WARRANTY
CAMPAIGN

Campaign no.: 2010-0008

Subject: **iCatch Handle Cable Breakage**

YEAR	MODEL	MODEL NUMBER	SERIAL NUMBER
2010	ADVANCED TEC™ iCatch trailer	T5AA, T5AC, T5AE, T5AG	All

1. iCatch cable area prone to break

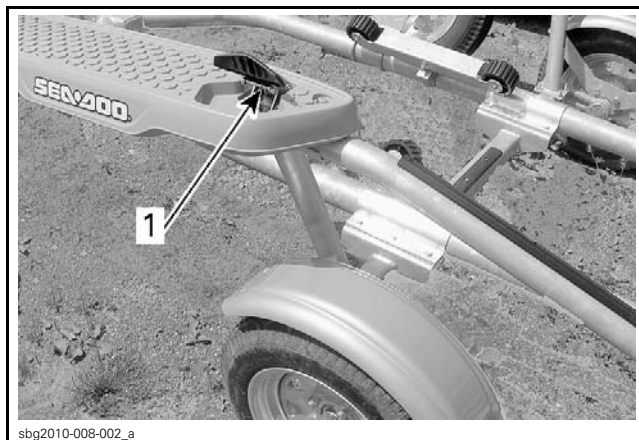
The iCatch cable may break at the release handle.

Replace the handle support and install cable spacers.

1. New handle support
2. Handle bolt with a new nut
3. Washer each side of support
4. 1/4 x 1" bolt and washer.
5. Cable hex bolt (1/4 x 2-1/2") and washer
6. Spacer
7. Cable eyelet
8. Washer and new nut

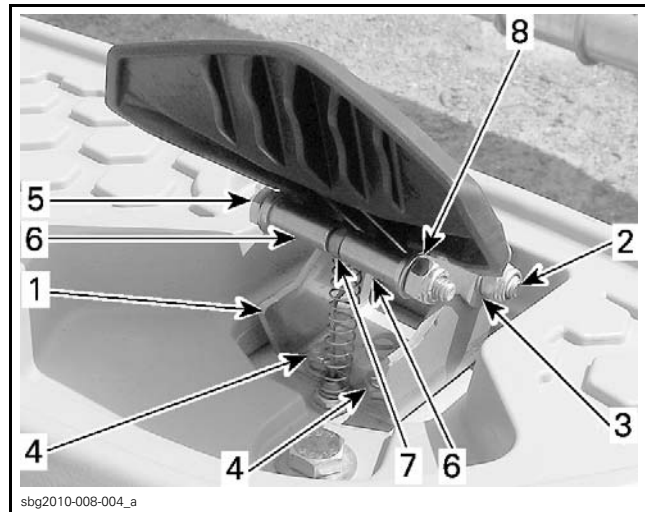
1. Install the new support onto handle.
2. Reinstall the handle bolt, washers and a new elastic stop nut (P/N 270 000 825). Snug the nut against handle support. Ensure handle works freely.

3. Install handle support to trailer using the following fasteners included in the PDI kit.
 - 2 x 1/4 x 1" hexagonal bolts
 - 4 x 1/4 washers
 - 2 x 1/4 nuts.
4. Tighten nuts to 7 N•m (62 lbf•in).
5. Install a washer onto cable retaining bolt (1/4 x 2-1/2"). Slightly push bolt through handle support hole then insert a spacer (P/N 269 800 369).
6. Pull cable end and push the bolt through the cable eyelet.
7. Install the other spacer (P/N 269 800 369).
8. Push bolt through the other handle support hole.
9. Install a washer and a new stop nut (P/N 270 000 825).
10. Snug the nut against handle support.
11. Ensure handle works freely and eyelet rotates freely on bolt and eyelet rotates freely on bolt.

NOTICE Do not overtighten to avoid release handle malfunction due to warpage of the release handle sides.

1. New handle support
2. Handle bolt with a new nut
3. Washer each side of support
4. Bolt and washer.
5. Cable retaining bolt and washer
6. Spacer
7. Cable eyelet
8. Washer and new nut

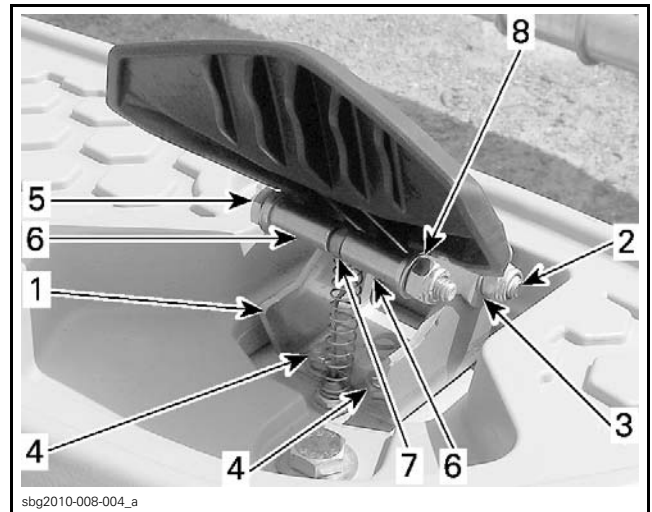
1. Install the new support onto handle.
2. Reinstall the handle bolt, washers and a new nut (P/N 270 000 825). Snug the nut against handle support. Ensure handle works freely.

3. Reinstall handle support to trailer using new nuts (P/N 269 800 160).
4. Tighten nuts to 7 N•m (62 lbf•in).
5. Install a washer onto cable retaining bolt. Slightly push bolt through handle support hole then insert a spacer (P/N 269 800 369).
6. Pull cable end and push the bolt through the cable eyelet.
7. Install the other spacer (P/N 269 800 369).
8. Push bolt through the other handle support hole.
9. Install washer and a new nut (P/N 270 000 825).
10. Snug the nut against handle support. Ensure handle works freely and eyelet rotates freely on bolt.

NOTICE Do not overtighten to avoid release handle malfunction due to warpage of the release handle sides.

1. Safety handle in lock position
2. Stopper
3. Handle resting against the stopper

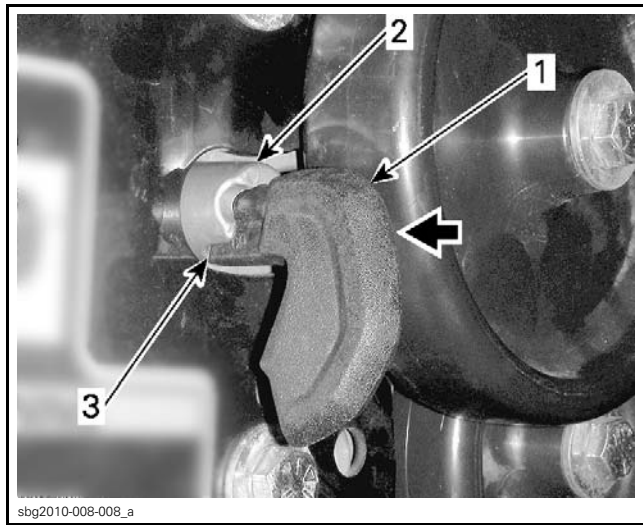
With the iCatch locked, ensure the safety handle rests against its stopper when it is in lock position.

NOTICE If the safety handle does rest against its stopper, it will not be properly locked. Therefore, the iCatch might open inadvertently.

If the safety handle is not in the proper position, readjust the iCatch cable.
